A-PRCP-NEW-100665536 – Response to Information Request

Information Request Response (IR issued 07/03/2025)

Progressive Rehabilitation and Closure Plan

Figure 12. Water Quality Monitoring Locations

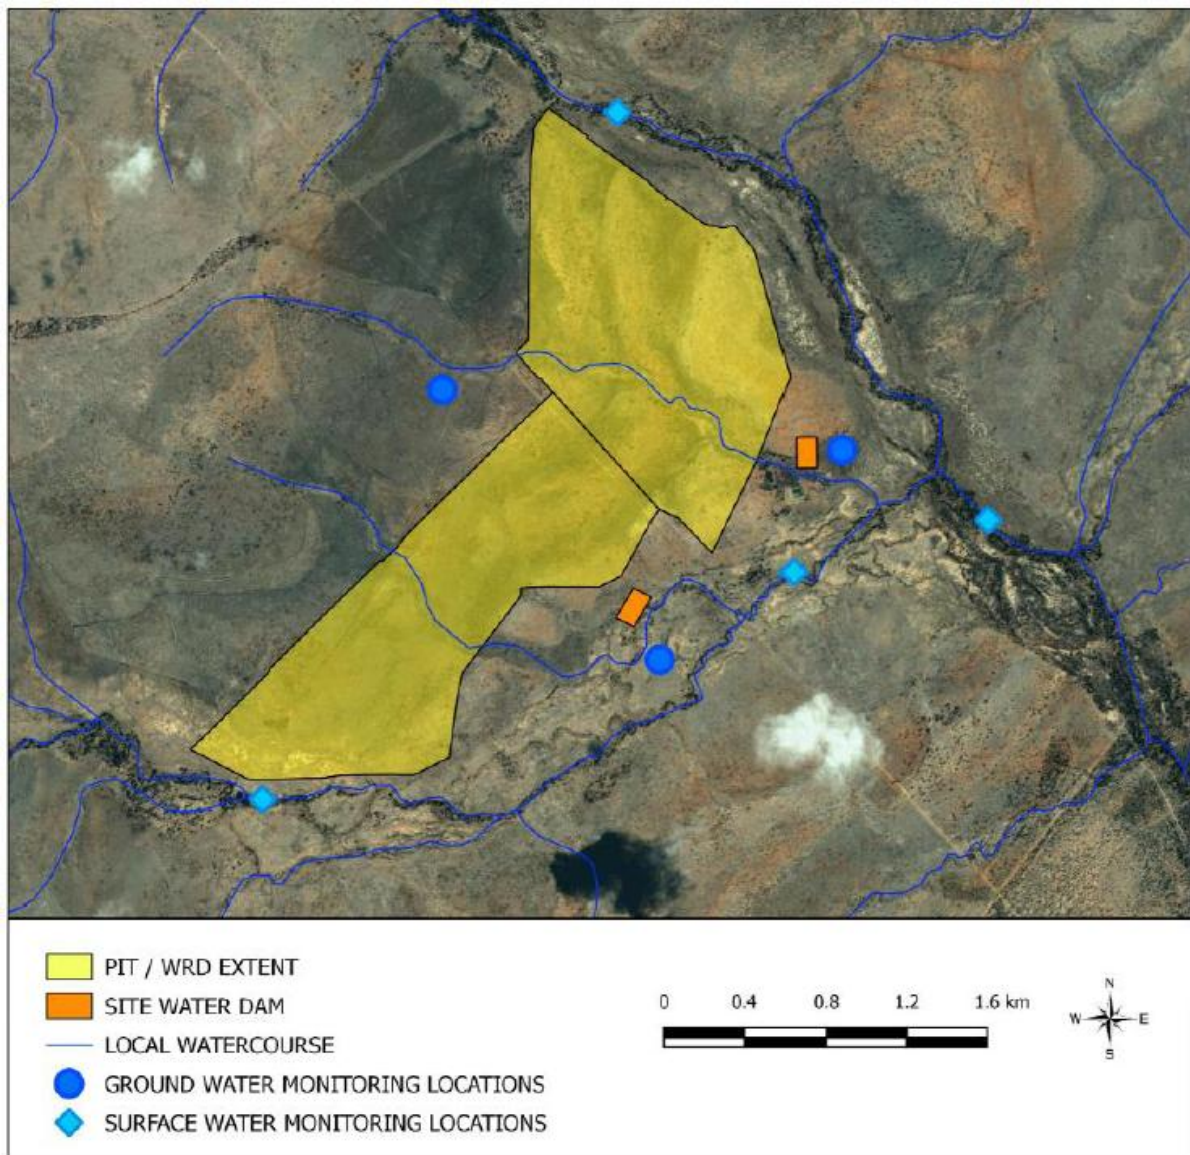
located hydraulically downgradient of the mine voids		
3	Surface water monitoring PRC plan Section 1.1.9. Surface Water Quality	<u>Monitoring Locations</u> The nominated upstream monitoring location is not upstream of the influence of disturbance from the mining activity. Upstream monitoring location/s should be revised to ensure that they are able to detect change influenced by upstream activities. <u>Monitoring Criteria and Limits</u> Some of the proposed monitoring criteria are not fit for purpose, for example: • RM7.6 proposes surface water run-off limits that do not include toxicants (Environmental Protection (Water) Policy 2009; Mackenzie River Sub-basin Environmental Values and Water Quality Objectives); and • Table 12. Surface water quality trigger values, proposes 'release limits' Background data can be used to determine site-specific limits. For surface water, the 80th percentile of data for upstream/reference sites should be used for phys- chem indicators and the 95th percentile for toxicants. The surface water monitoring and reporting for the PRCP should be done to ensure that the final landform is stable and non-polluting not to ensure compliance with the EA.	Provide a PRC plan inclusive of: a) appropriate surface water rehabilitation and closure monitoring locations, monitoring frequency, quality characteristics and limits that are fit for purpose and capable of identifying contamination from all disturbed areas; and b) an updated monitoring program that includes limits that are fit for purpose (closure not operation), and able to demonstrate a stable and non-polluting condition has been achieved.	PRC Plan and Schedule have been updated. See the attached document, 'PRCP Water Monitoring Program'. Interim quality values have been suggested these will be finalised following collection of additional data during flow events ie. Develop site specific triggers.

Figure 19. Final void depression and the 0.1% AEP Maximum flood depth

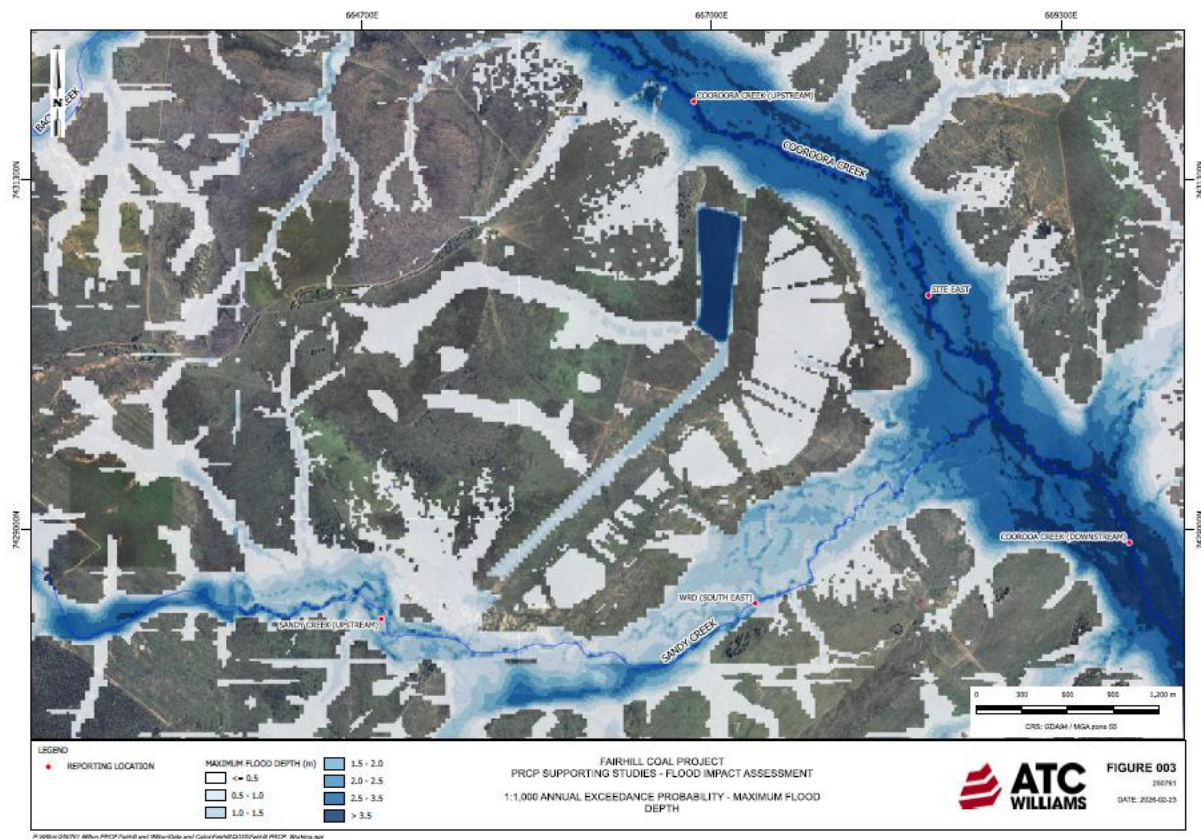
5	Final landform - Open Cut Depression PRC Plan Section 4.4. Statutory Constraints to be Imposed; and PRC plan Section 6.2. Landform Design; and Appendix M Mine closure plan	Features in Floodplains and Water Ingress PRCP Figure 11 (Fairhill Coal Project PRCP, 2025) shows water ingress into the pit and WRD under the 0.1% AEP flood event from Cooroora Creek and Sandy Creek. The PRCP (Section 4.4.1) states: "The final pit depression will have negligible overlap, and the landform will be designed to be higher than the peak water level of 0.1% AEP as modelled." However, PRCP Figure 19 (Fairhill Coal Project PRCP, 2025) demonstrates partial overlap between the open cut depression, WRD and the 0.1% AEP flood extent. This contradicts PRCP Guideline ESR/2019/4964 (Section 3.4) and EP Act (Section 126D(3)), which require that: No void is situated wholly or partly within the 0.1% AEP floodplain All landforms within a floodplain must be rehabilitated to a stable condition. If any depressions remain within the 0.1% AEP floodplain, consideration should be given to how the landform could be re-engineered to avoid 0.1% AEP flood.	Provide a PRC plan inclusive of flood modelling that is based on the final landform and demonstrates the following: - final depressions are situated wholly or partly within the 0.1% AEP floodplain are minimised; and - all landforms within a floodplain will be rehabilitated to a stable condition (i.e. long-term stability will not be adversely flood-impacted). - Details of any engineered barriers (e.g., flood protection bunds, backfilling strategies) that are required to ensure that the landform remains safe and self-sustaining or consider adjustments in the final landform.	A Water Balance Study of the Final Depression has been completed (Appendix C2) The study demonstrates that the void is predicted to be non-spilling and would act as a localised groundwater sink. When the void is backfilled to 140m AHD as proposed, the water level in the void is expected to fluctuate between almost no water to on average having a few meters of water present. The water level remains below the final landform spill level. Salinity is forecast to increase steadily with time reaching 50 and 250 mS/cm after approximately 500 years Further design work on the final landform is required and the Landform design Report and PRC Plan will be updated to align with the designs which will be needed to be able to demonstrate support of the PMLU.

Figure 20. Modelled 3D Landform Design

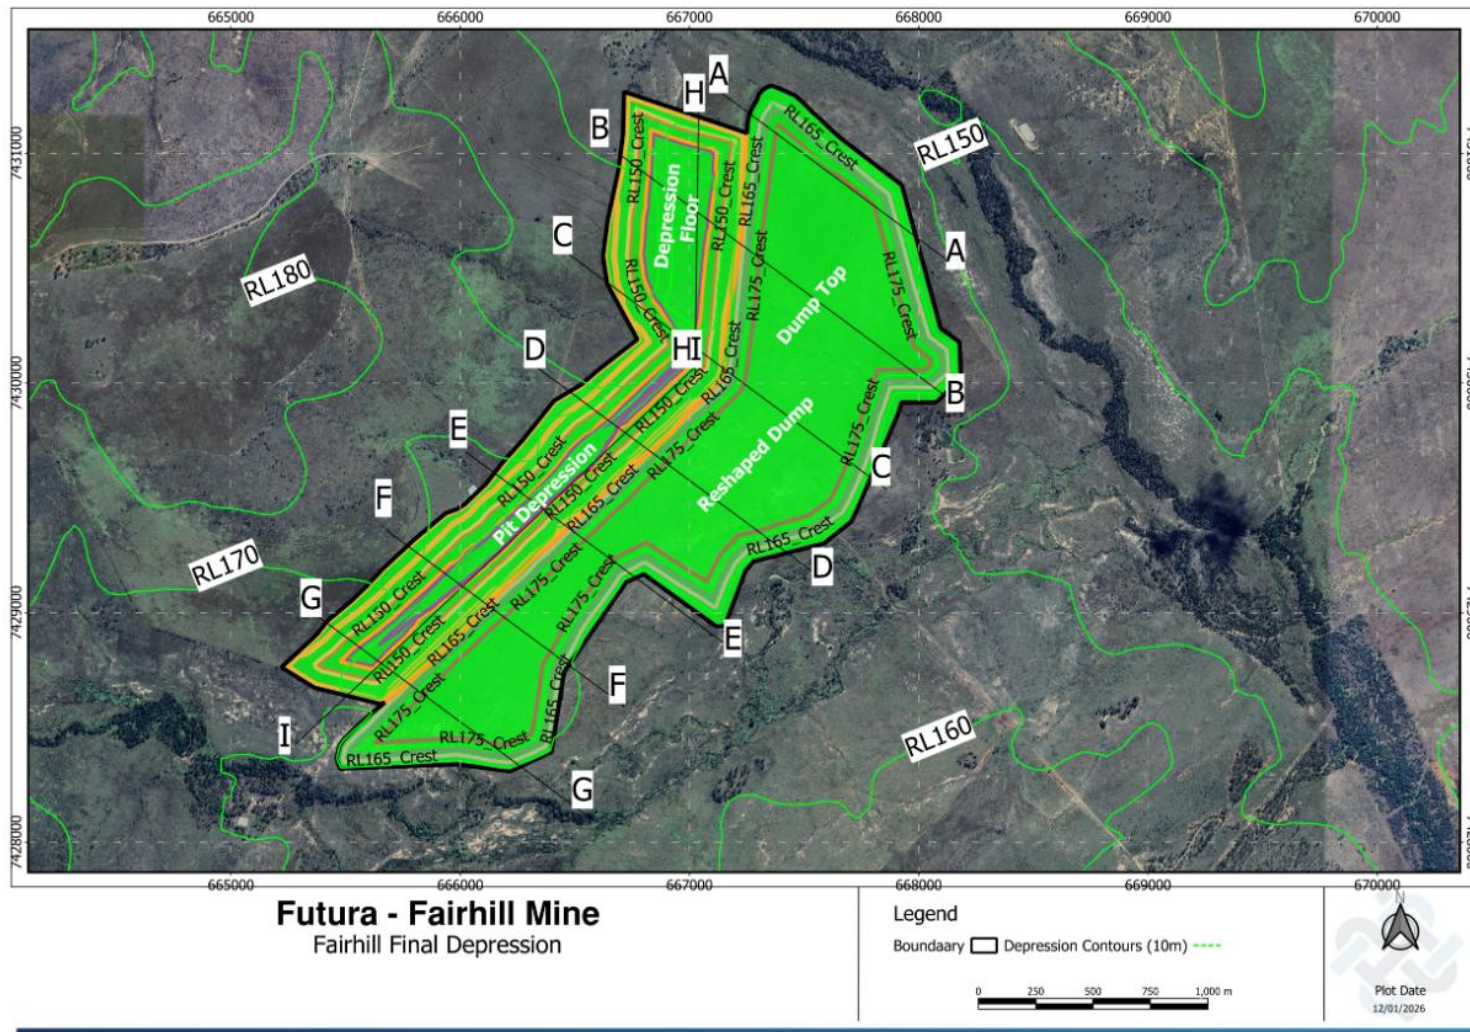
<i>design and rehabilitation schedule</i> and in <i>Figure 7 Final landform</i>, that slopes in the final landform will be up to 30%. The PRC plan and schedule should propose a land outcome including criteria that are consistent with those identified in a land outcome document, in this case, the EA, in order to retain the transitional provisions. If it is the intent of the PRC plan to propose landform criteria different to those that are pre-approved, further information is requested to demonstrate how the landform criteria will achieve the same PMLU. Slope suitability for PMLU The PRC plan proposes slopes that exceed the criteria for agricultural land suitability assessment (LSA) of grazing. It should be noted that advice published by the Queensland Mine Rehabilitation Commissioner (QMRC), identifies class 3 slopes as being less than 20%, refer to Rehabilitated mined land suitability for beef cattle grazing in the Bowen Basin: Technical Paper, <i>Table 10. Criteria used to differentiate subclass limitations for slope gradient</i>. Further, the QMRC publications indicate that to achieve an acceptable grazing land use, land class should be assessed as class ≤ 3. On this basis, the PRC plan should demonstrate	published advice by the QMRC. This should consider alternative PMLU's which may be more readily achieved at the desired slope angles.	Note: Futura's rehabilitation will aim to re-instate the inherent / pre-mining grazing potential of the land. The completion criteria in the EA make this very clear and reference the LFA methodology to demonstrate this.

Figure 21. 3D Final Landform Cross Sections

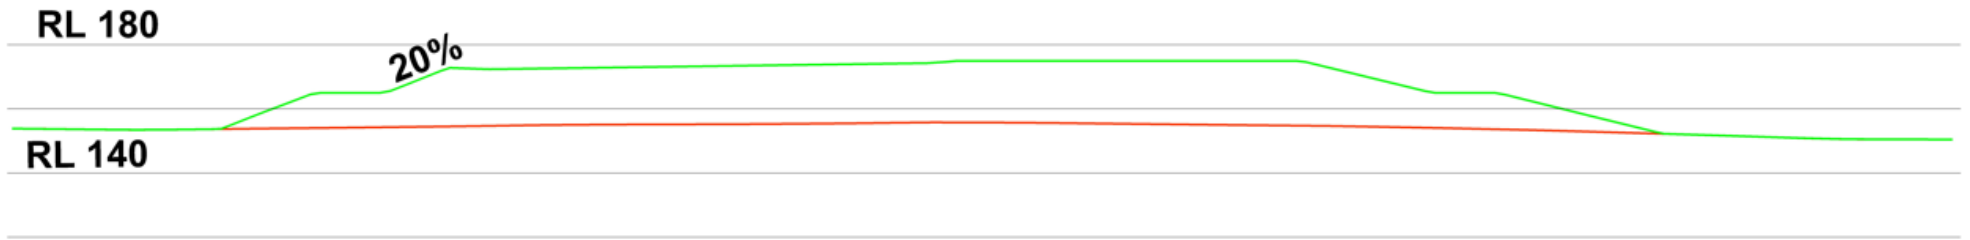
across PRCP figures. ii. The cross-sections in the PRCP (Figure 22, Page 73) are difficult to interpret due to unclear axis labels and resolution issues, making it unclear if the final landform complies with the EA's 25% slope requirement. iii. Some figures in Appendix M indicate a possible flood levee west of the pit, but this is not discussed in the PRCP rehabilitation criteria or final landform stability.	• Explicit depiction of all depressions/voids, ponded areas, and drainage paths. (c) Confirm if a flood protection levee is part of the final design and, if so, how: • Its function aligns with long-term landform stability. It meets EP Regulation 2019 requirements for final landform stability.	has been updated with further detail and is now included in the PRC Plan document. Refer to Figure 21 and Figure 22. Further updates to the final landform design report are expected in the next amendment based on the outcomes of the water balance model for the final depression.
